# TC NO. CAL. Development Warehousing and Distribution Facility Project Final Environmental Impact Report

DRAFT

Prepared for the Port of Stockton

Anchor QEA, LLC  
33 New Montgomery Street, Suite 1210  
San Francisco, California 94111

Figure 2 TC NOR CAL Development DEIR Site Map with Mitigation

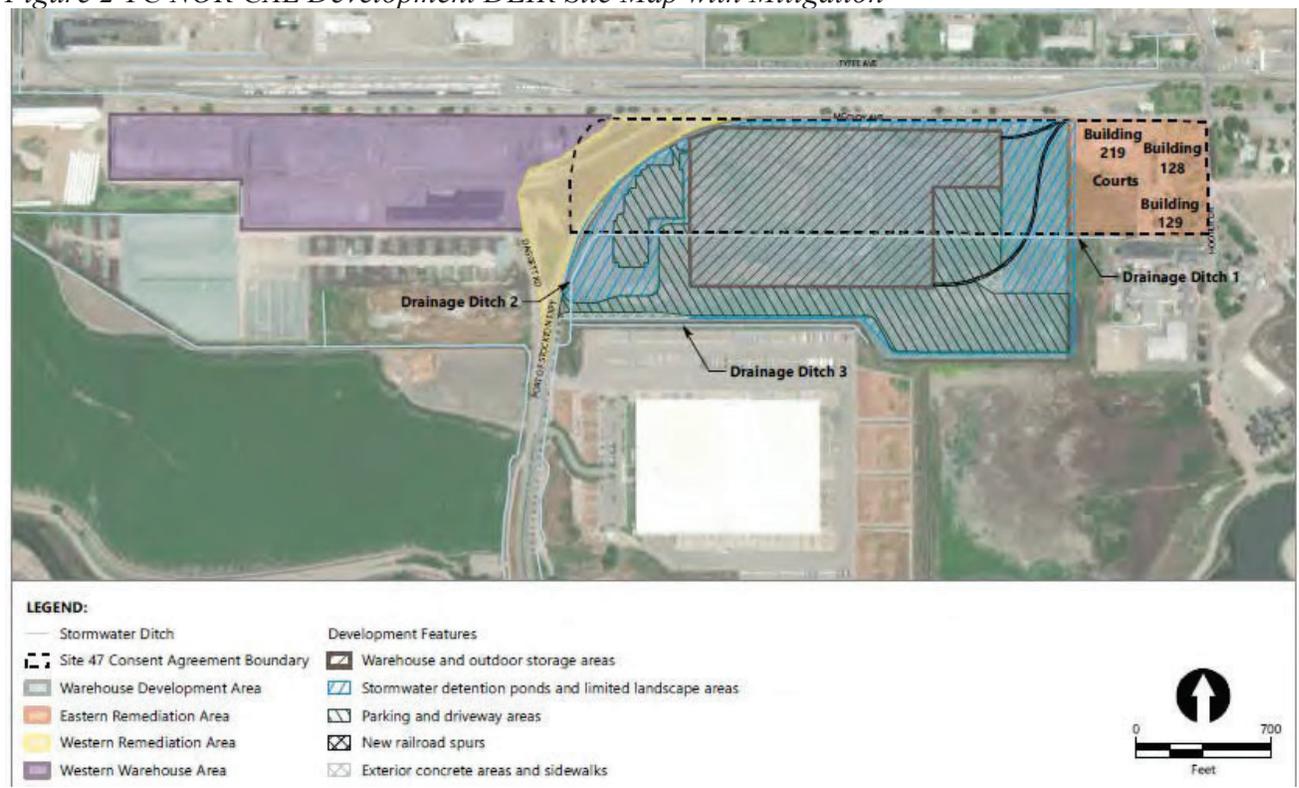
As part of the proposed project, remediation would occur in areas throughout the 102-acre project site, which includes the proposed 60-acre site on which the warehouse would be developed, as well as approximately 42 acres to the east and west. The remediation site is referred to as Site 47. The DEIR reported the status of remediation as in the Remedial Investigation/Focused Feasibility Study (RI/FFS) phase which is under development by the Port and TC NO. CAL. Development. The purpose of the Site 47 RI/FFS is to assess site conditions and evaluate alternatives to the extent necessary to select a remedy that will be documented in the Remedial Action Plan (RAP). Please forward notification to the Delta-Sierra Group when the RI/FFS is available for public review while under review by the California Department of Toxic Substance Control and the Central Valley Regional Water Quality Control Board, as it is reportedly still under development.

*Figure 4 DEIR Site Plan*

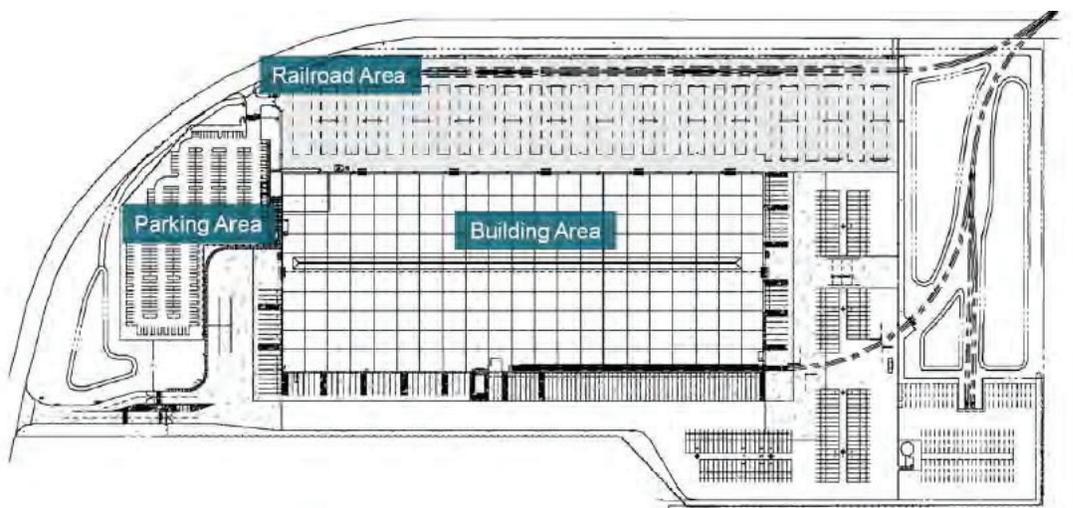
Additional information regarding how the site plan will achieve the logistical goals set forth in the DEIR is needed and should be included in a FEIR. The number of truck docks was not specified in words although the DEIR included the following site plan.

Figure 5 Transportation Injury Mapping System, UC Berkeley – Truck involved Accidents

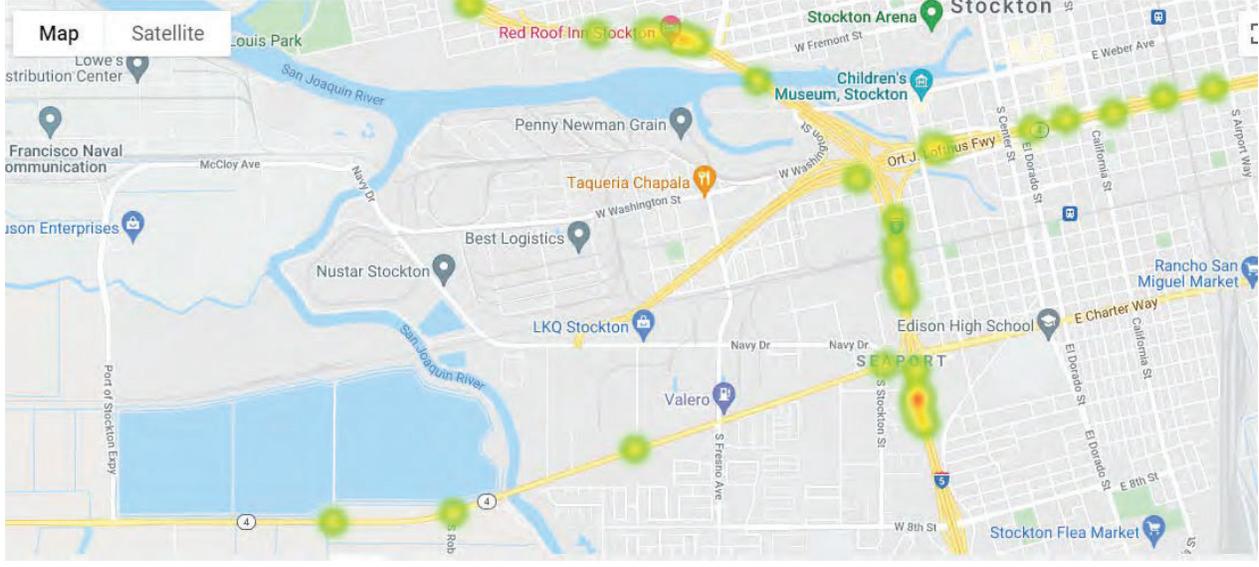
Increased truck traffic will not only result in decreased levels of service on roadways and increased wait times but will increase the likelihood of traffic accidents. The following is a heat map showing where truck involved accidents have occurred between 2018 and 2020 on Interstate 5 and Highway 4 (Charter Way) in the general area of the Port of Stockton<sup>5</sup>.
